DOCUMENT 00 90 00
ADDENDUM

ADDENDUM No.: 2

RE: WESTERN TECHNICAL COLLEGE
KUMM CENTER STUDENT UNION REMODEL
400 N. 6TH STREET
LA CROSSE, WISCONSIN 54601

PROJECT No.: 25041

3 BASEMENT PLAN
3/16" = 1'-0"

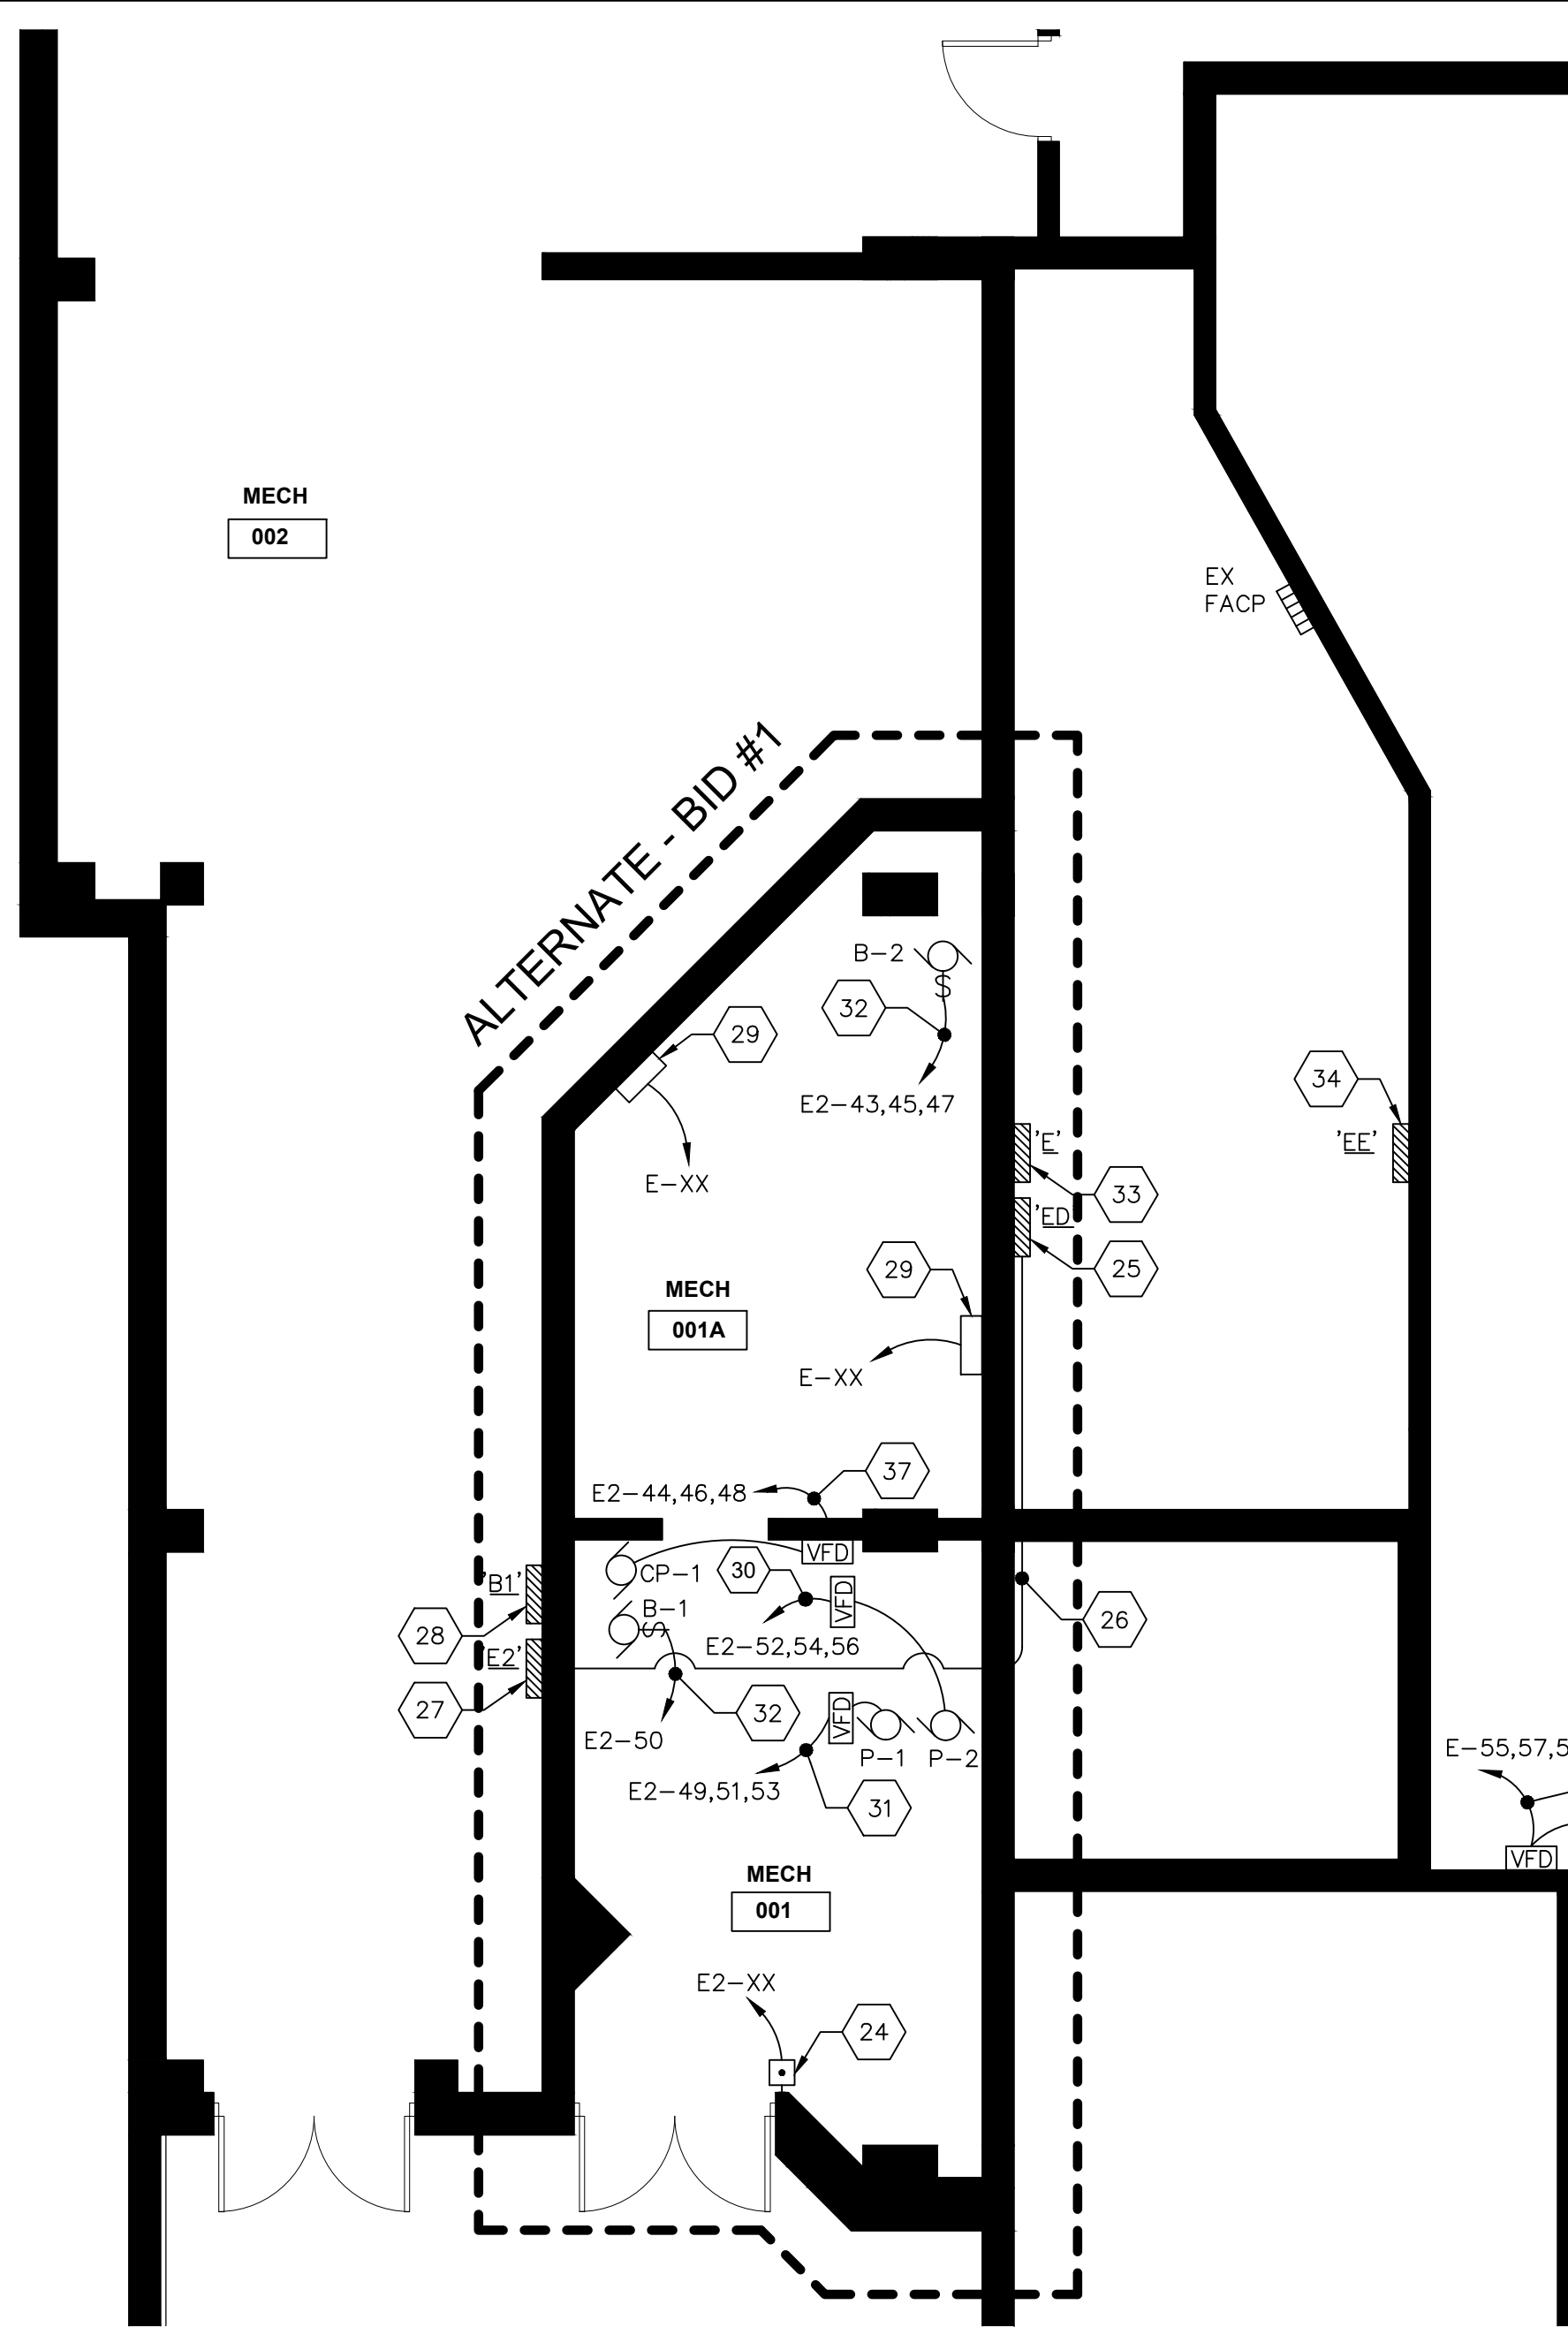
- a. See the revised sheet included in this addendum. Disregard the previous version.
 - b. Refer to Vestibule #101 and Corridor #102;
 - i. Reconnect Two (2) new replacement motorized door openers and associated low voltage control switches on existing doors. Please note, Two (2) motorized door openers were previously disconnected for removal and Two (2) new replacement motorized door openers were installed on existing doors. Reuse existing branch-circuit wiring, low voltage wiring and paddle type control switches. Coordinate with General Contractor, field verify existing conditions prior to submitting bid to determine scope of work.
